Response to MassDevelopment with Respect to
The Residences at South Brookline

December 13, 2012

RE: Chapter 40B Comprehensive Permit

Project Name: The Residences at South Brookline
Location: Independence Drive, Brookline, MA
Number of Proposed Units: 271
Subsidizing Agency: Massachusetts Development Finance Agency
Applicant: The Residences of South Brookline, LLC
Development Company: Chestnut Hill Realty

Figure 7: Detail Ring Plan

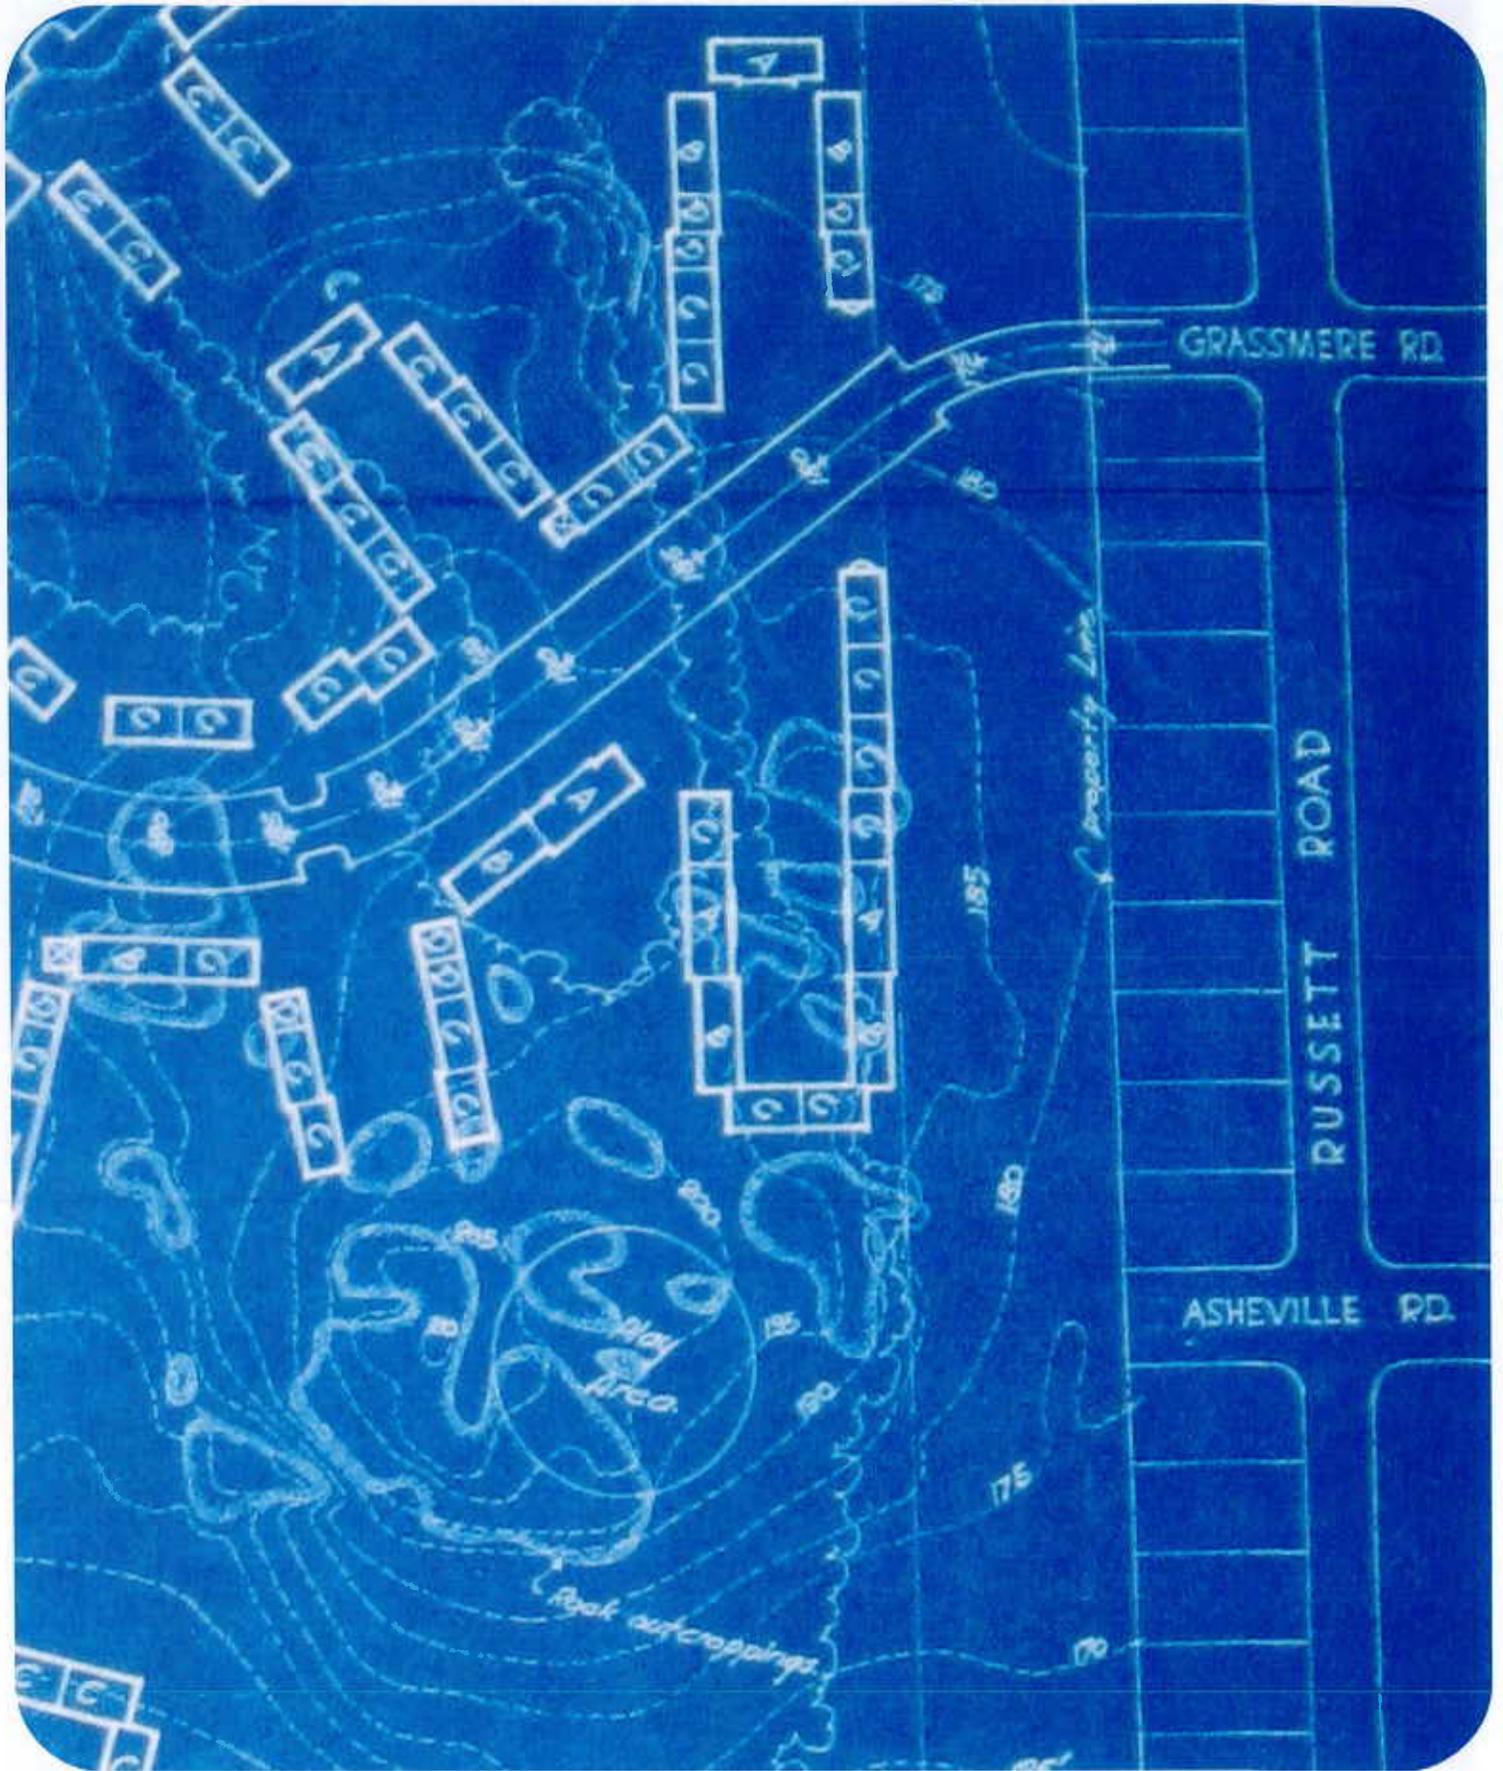
Whereas the original vehicular pattern for Hancock Village was circular and integrated (see Ring Plan – **Figure 6**), the proposed plan would add four additional dead end driveways. This type of site planning not only compromises the free and open feel of Hancock Village, but also worsens accessibility for emergency vehicles. It appears from the information provided by the developer

The proposed project would more than double the number of vehicles whose sole access would be to and from this rear 18-foot wide driveway which will negatively impact the community through an increase in motor vehicle volumes and speeds. Perpendicular parking spaces would also be added to the end of Asheville Road at the site's edge. The site plan does not include safe, adequate or separate pedestrian access at this edge of the site. Most of Baker Elementary School children and their families walk to school; the Russett/Asheville Road

Figure 10: Limited Sight Distance Plan

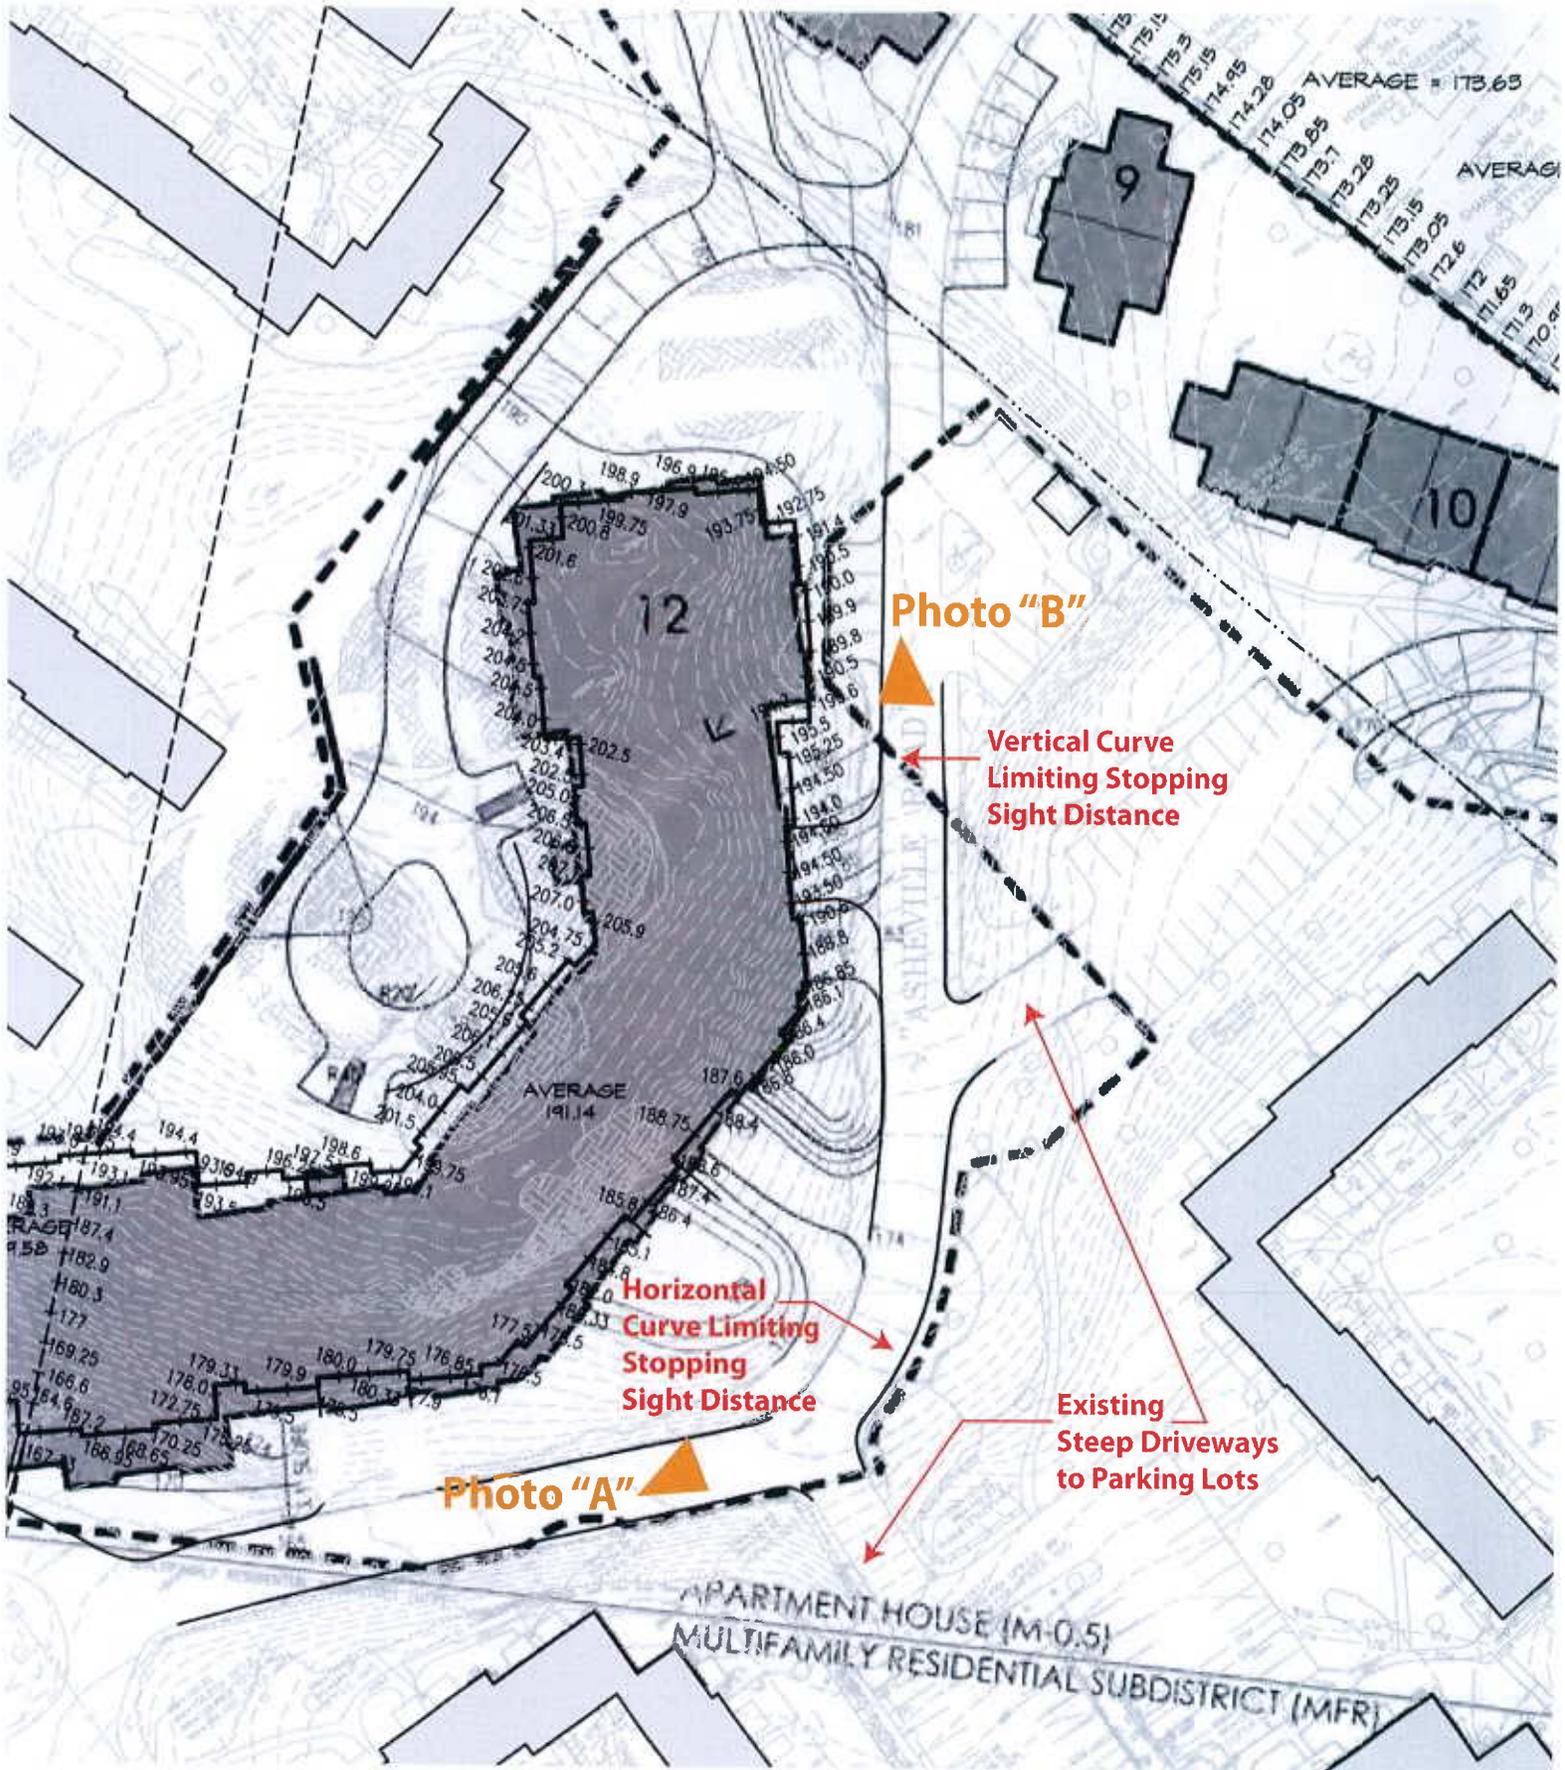
The proposed five-story apartment building is sited such that two new intersections will be created along the curve of the existing Asheville Road driveway. Standard safe Stopping Sight Distance (SSD) for a 15-mph zone is 80 feet. However, as shown in **Figures 10 and 11**, horizontal and vertical curves in the existing Asheville Road driveway, combined with multiple parking lot driveways entering at very steep grades, already limit the line of sight. The submitted application does not include information related to Stopping Sight Distance. The Town estimates that the Stopping Sight Distance along this driveway as proposed will not meet these standards. With 144 additional cars entering and exiting along the curved driveway, the proposed project design for this large building cannot be accommodated on the Asheville Road driveway.

Note: Plan shown is 1"=60' scale. The base plan (existing topo) has been combined with materials submitted recently for the Comprehensive Permit to better illustrate the inappropriateness of utilizing the driveway off Asheville Road for vehicular access/egress to the proposed building. Photos A & B included as Figure 11.

Scale: 1"=50'
Figure 13: Russett Road Neighborhood Section

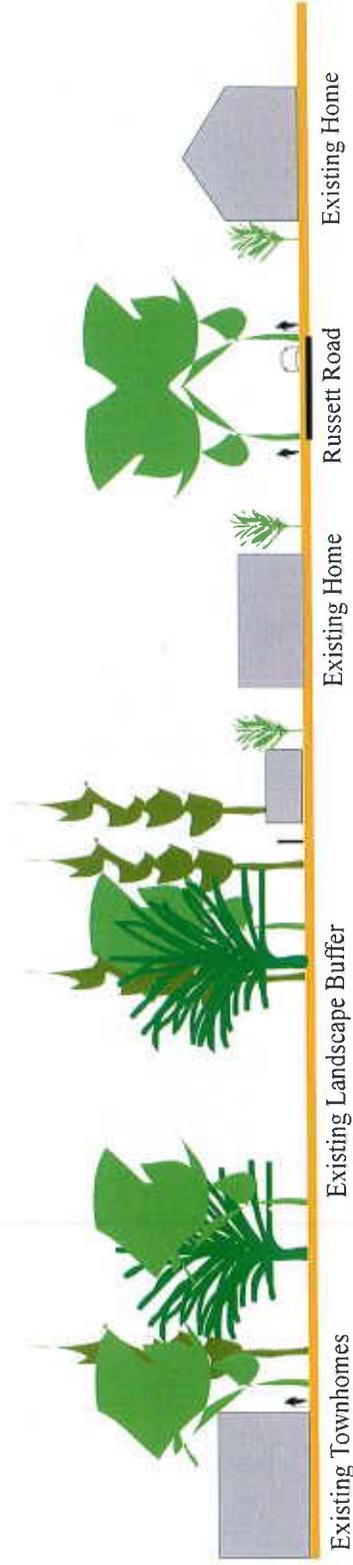
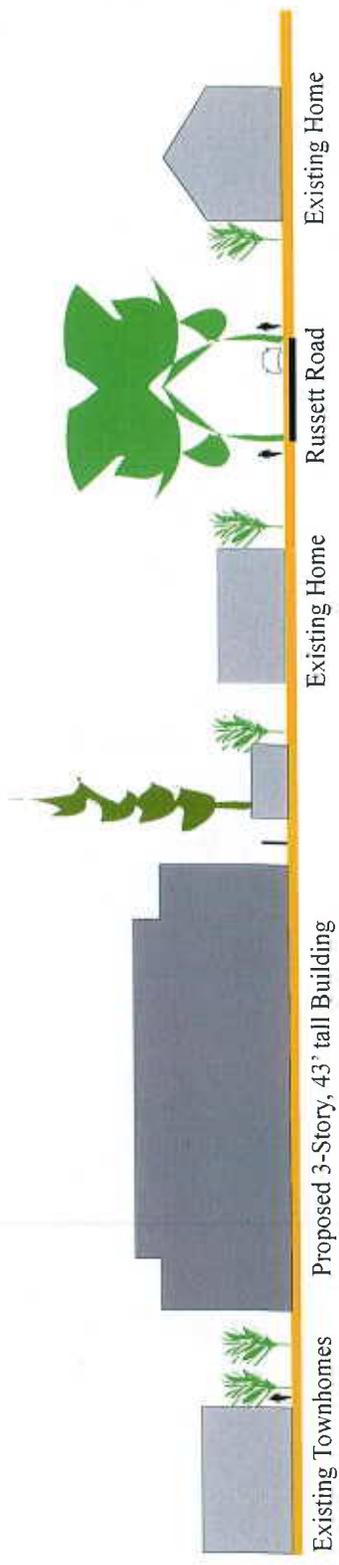
As shown in the attached Russett Road Neighborhood Section (**Figure 13**), multi-family buildings as proposed will not only eliminate completely the existing greenbelt between Hancock Village and the adjacent single-family neighborhoods, but will also set the proposed buildings within five feet of the adjacent single-family lots.

Figure 15: Typical Building-Landscape-Road Sections
Scale: 1"=30'

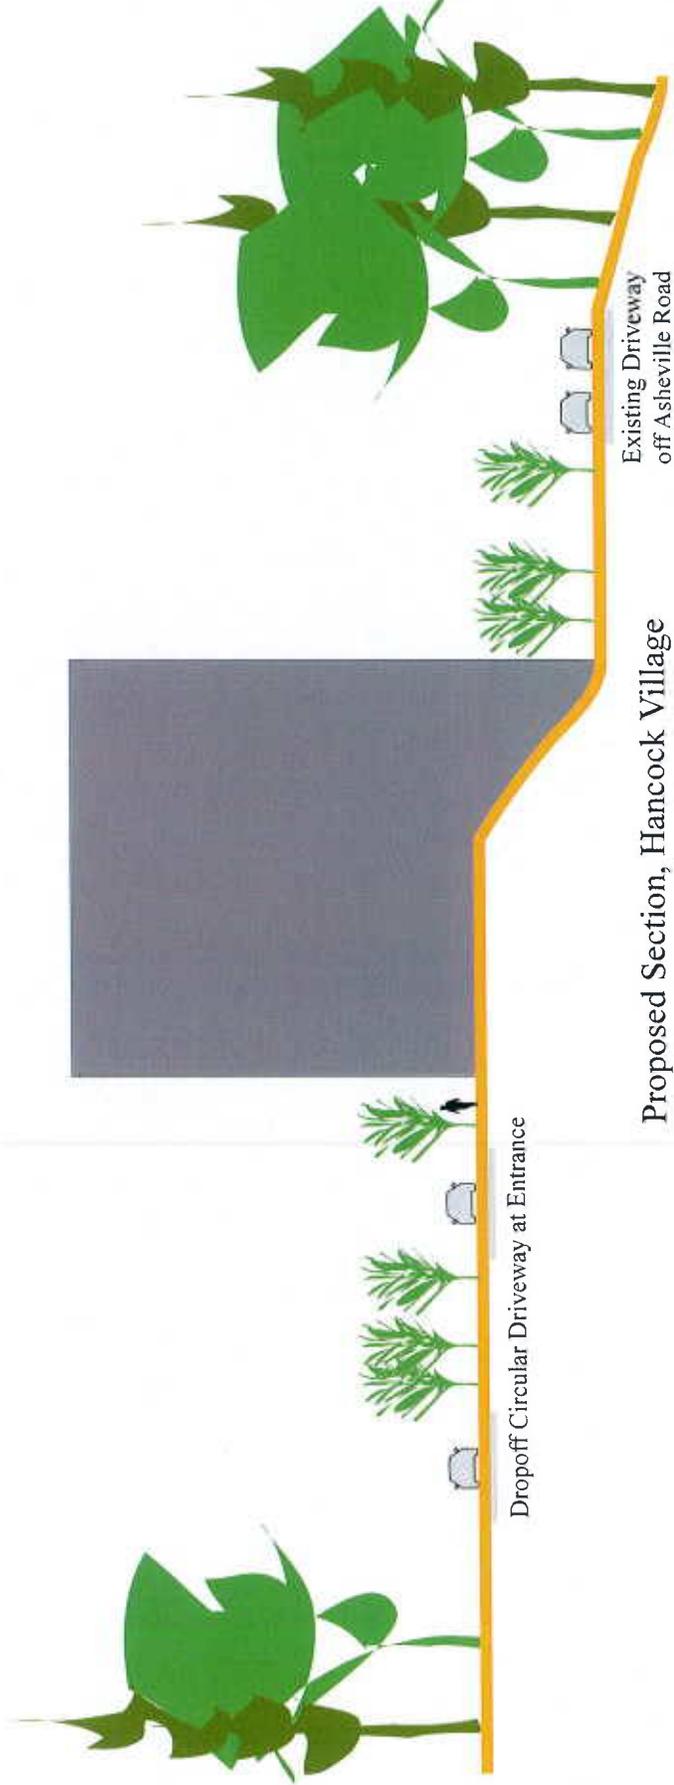
The building-to-street relationship is not upheld in the new plan. Existing streets are narrow and so are the buildings they serve. The residential area surrounding Hancock Village comprises single-family residences, built primarily in the 1930s and 1940s, conservation land, an elementary school and its grounds, and a state

parkway listed on the National Register of Historic Places. Refer to Typical Building — Landscape — Roadway Section (**Figure 15**), highlighting how the relationship between the height of proposed buildings to the width of the streets (with little room for landscaping in between) would be significantly different from the existing street patterns, both inside and outside the boundaries of Hancock Village. Unlike the single-family homes and the townhomes of modest scale set on narrow streets, with landscaped front yards and separated pedestrian access, the proposed project includes large buildings sited without any reference to existing building-to-street patterns.
